TECHNICAL NOTEEdition Anglaise

TWINGO

RE-PROOFING THE LOWER WING PANEL ROUNDED SECTION TO ACCOMMODATE SNOW CHAINS

Basic Manual: M.R. 306

UPPER FRONT STRUCTUREWing Panel (pillar lining)

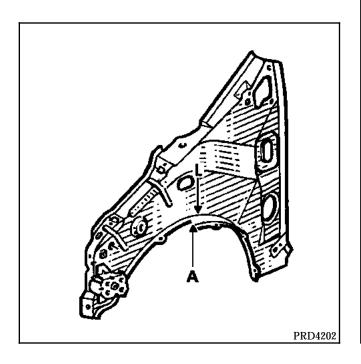
The radius of the wing panel rounded section (pillar lining) has been increased to allow the fitting of snow chains. Therefore, on an older vehicle, for partial replacement of this component when cutting the middle of the rounded section, it will be necessary to adjust the shape of the edging of the part supplied by the Parts Department (see method described in the technical note).

PART SUPPLIED BY THE PARTS DEPARTMENT

ON THE VEHICLE

Shape the edge of the original along the line (L) in such a way as to adjust the rounded section of both parts of the component, then cut off any excess metal at (A).
